## 2. COA-057055-2019

3017 East Marshall Street

# Commission of Architectural Review

## STAFF REPORT

Figure 1. Sanborn Map, 1905

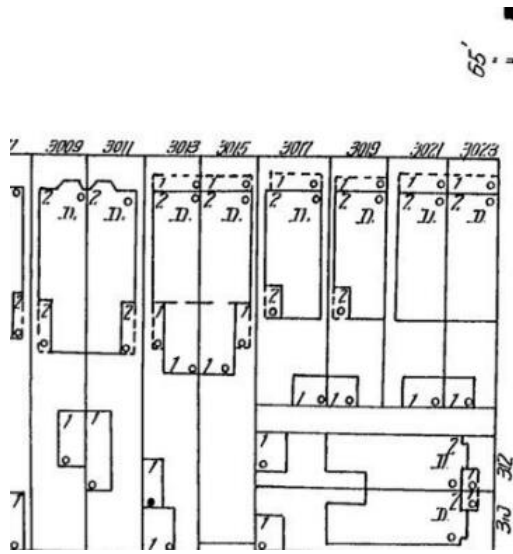
Porches, Entrances & Doors, pg. 71	<i>The entire porch should only be replaced if it is too deteriorated to repair or is completely missing; replacements should match the original as much as possible.</i>	Staff has visited the property and has confirmed that the porch is greatly deteriorated and is currently being held in place with temporary bracing. Staff recommends the existing porch be removed.
Reconstruction of Missing Historic Elements Administrative Approval Guidelines	<i>The Commission staff may approve a reconstruction of missing elements based on the following criteria: architectural inventory documentation, including assessment records, insurance policies, and historic inventories; and architectural remnants on an attached or adjoining building.</i>	<p>The applicant requests permission to reconstruct a one-story porch. The applicant has provided photographic documentation which indicates the current columns and decorative details are not original to the building. Based on Sanborn map and historic photographic documentation staff believes the house originally had a half-hipped roof and staff recommends approval of this roof form. Staff further recommends the columns be simple square, full-length posts and that no other decorative details, such as the proposed dentils, be utilized.</p> <p><u>Staff recommends that during the demolition phase of the project, if any physical evidence is revealed which indicates the historic location and configuration of the roof profile that staff can administratively approve the roof form based on this evidence.</u></p>

- Staff recommends that during the demolition phase of the project, if any physical evidence is revealed which indicates the historic location and configuration of the roof profile that staff can administratively approve the roof form based on this evidence.
- The columns be simple square, full-length posts and that no other decorative details, such as the proposed dentils, be utilized.
- The roof material specifications, including the seaming details, be submitted to staff for review and approval.
